# PDB issues and Production Plan

AUW (April 08, 2019)

# ... but when Vicor and Keysight LVPS have been used...

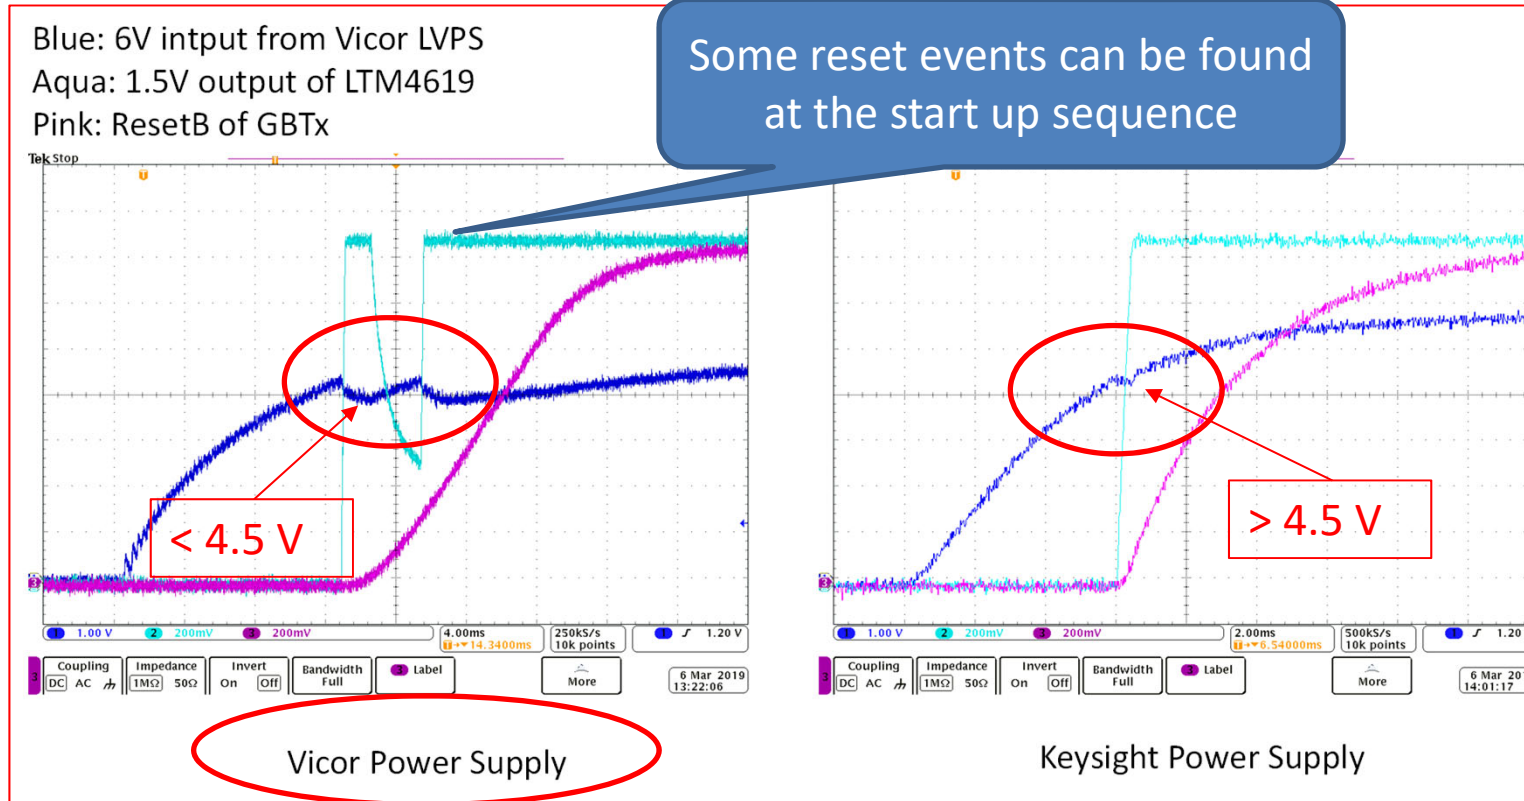
- One or more short reset events of the LTM device can be observed (in particular with VICOR LVPS).
- This is mainly due to the behavior of the output voltage of the LVPS (which is the input voltage of the LTM).
- This is well clear when the LTM starts (see the red circles on the figures).
- The output voltage of the power supply tends to decrease just enough so that in some situations it falls below the minimum operating value of the LTM devices (4.5 V).

# Proposed solutions

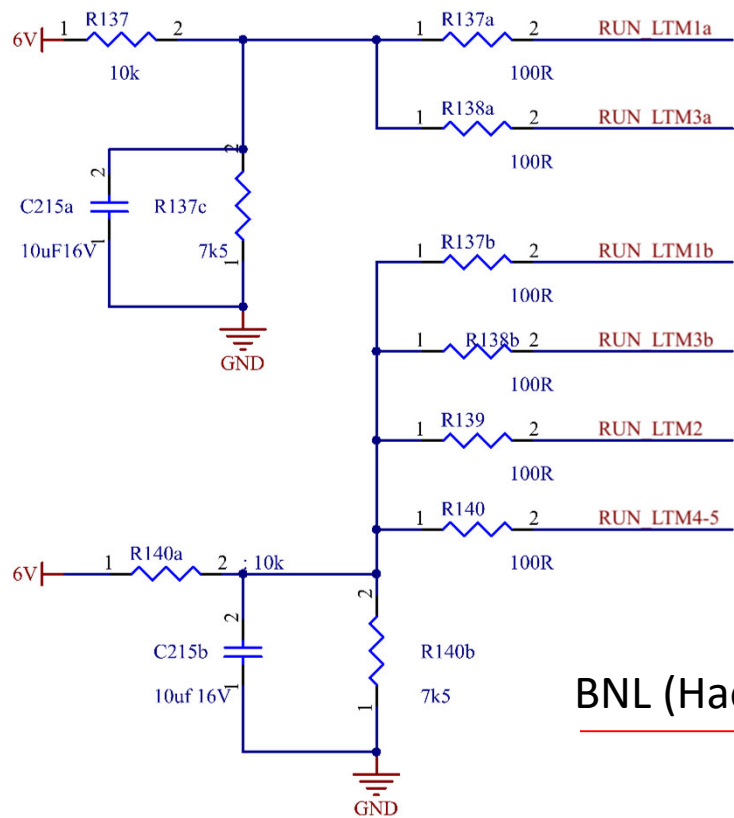
- To avoid this dependency from the LVPS, cables, etc... different solutions have been discussed.
- In the end it was decided to implement the following modification to the PDB:
  - delay the switching ON of the LTM device when the LVPS device has reached a value of its output voltage ( $\gg 4.5$  V) such as to prevent the switching OFF of the LTM device*
- This soft start circuit modification is strictly necessary only for the 2 output voltages from LTM 1 and 3 but, in order to have the best flexibility, the new circuit has been implemented for all the LTM devices.

# Proposed solution

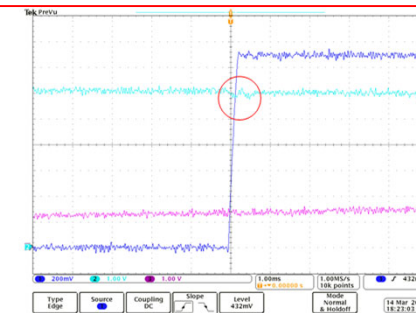
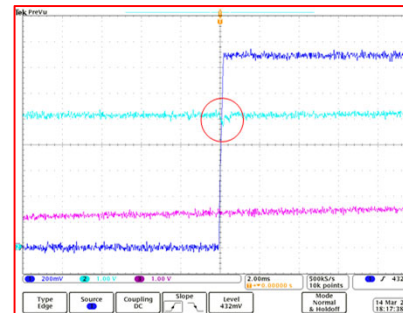
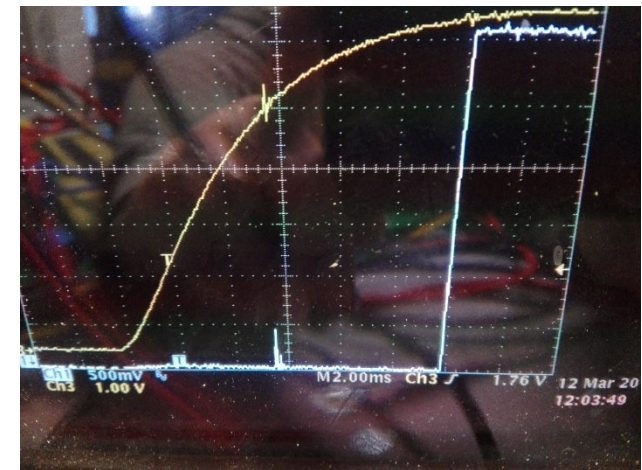
- Vicor LVPS
- 10K/7.5K/10uF
- **No start up trip**
- Drop off of 6V input is ~400mV

- Wiener LVPS
- 10K/7.5K/10uF
- **No start up trip**
- Drop off of 6V input is ~200mV

- Solution successfully tested on PDB v3 both in Milano and at BNL
- Change implemented in PDB v4
